MEMORANDUM

From:	Ben Amey Development Control		
Service	WBC Highways	App No:	251105
Address:	The Sapphire Centre, Fishponds Road, Wokingham, RG41 2QL		
Proposal:	Proposed Extension to the Rear of the Existing APACOR Facility by Connecting with an Existing Commercial Building to the Rear with associated works		
Site Visit Made:	Yes (10 th and 11 th June 2025)

Consultation Response

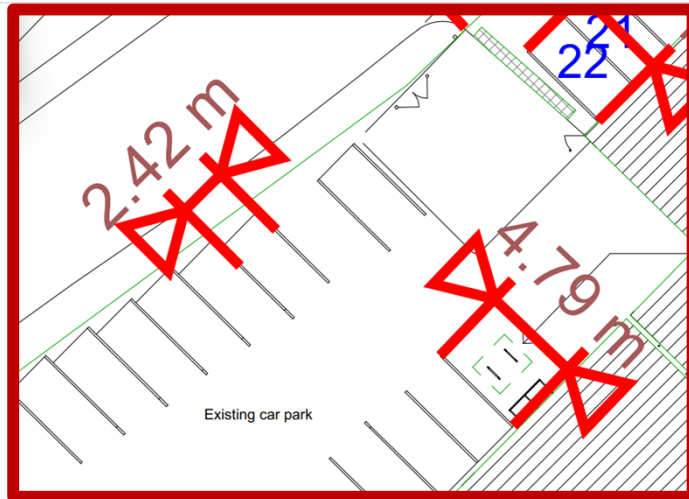
7. There is a shortfall in proposed number of car parking spaces when measured against the WBC Parking Standards for B2 Industrial Use. It has not been demonstrated that the site would accommodate expected level of parking and prevent overspill of parked vehicles onto the surrounding roads. The additional 1010sq.m of B2 Industrial floorspace requires an additional 25 car parking spaces, 5 cycle parking spaces and 2 motorcycle spaces.

8. The existing car parking was observed to be fully occupied by existing staff during a site visit on 11th June 2025. Therefore, the LHA is concerned that the proposals do not provide car parking in accordance with the WBC Car Parking Standards, given an enlarged building could increase no. of staff and parking demand. Photos of car parking occupancy on 11th June 2025 are provided below:
